Franklin Township

MEMORANDUM

Ananda Mandir, Inc. – Temporary Use Permit (ZBA-20-00015)

269 Cedar Grove Lane (Block 508.02; Lot 5.03)

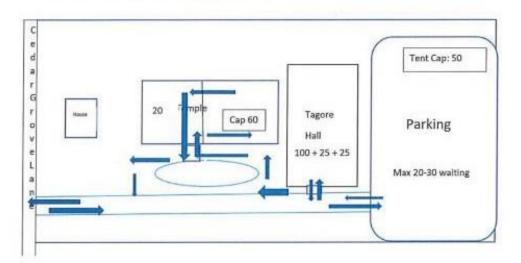
1. The sketch is not detailed enough for an appropriate review. The proposed should be overlaid on a copy of the site plan with the various proposed elements (e.g., tent, etc.) drawn to scale.

After such a plan is presented staff will be able to review and potentially comment on issues such as available parking, vehicular circulation, emergency access, protection of occupant of the tents from vehicular traffic, etc.

AM Response: Please see the attached diagram. Explanation of Foot Traffic:
